NOTICE OF VIOLATION

On January 29, 2025, Energy Safety conducted an inspection of PG&E's WMP initiatives in the vicinity of the city of Cool, California. The inspection report is enclosed herewith. Energy Safety found the following violation(s):

INSPECTION REPORT

Item1IA1Img1: No covered conductor installed east of pole 121530972

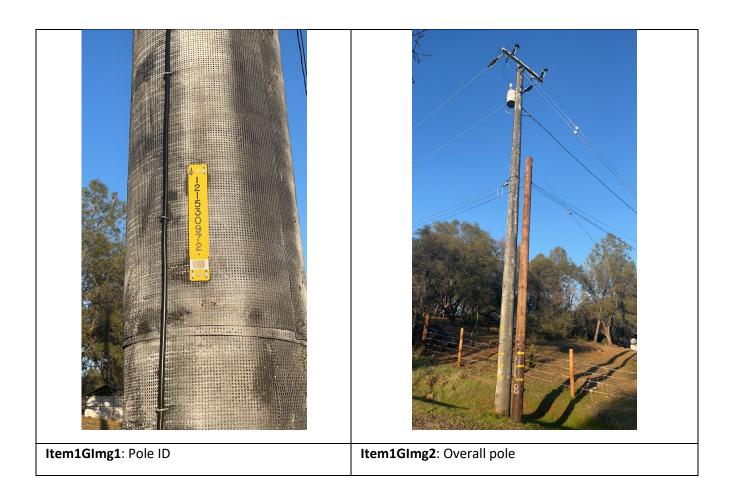
On pole ID 121394336, Grid Hardening ID 35293673 at 2344-2350 Talking Pines Ct, Cool, CA, 95614, USA, 38.896734279315865, -121.00891927372464, the inspector observed no covered conductor installation on the pole east of pole ID 121530972. The inspector's observation is documented in Violation 1 photographs, which are attachments to this report. Photo numbers Item1IA1Img1, Item1IA1Img2, depict no covered conductor installation. PG&E reported that work on WMP initiative 8.1.2.1 -Covered Conductor Installation — Distribution was completed at this location.

- PG&E reported that covered conductor was installed east of pole ID 121530972in PG&E's 2024 Q2 QDR data.
- 2. Covered conductor was not installed east of pole ID 121530972.
- 3. A secondary distribution line and a secondary service pole were observed at this location, east of pole ID 121530972.
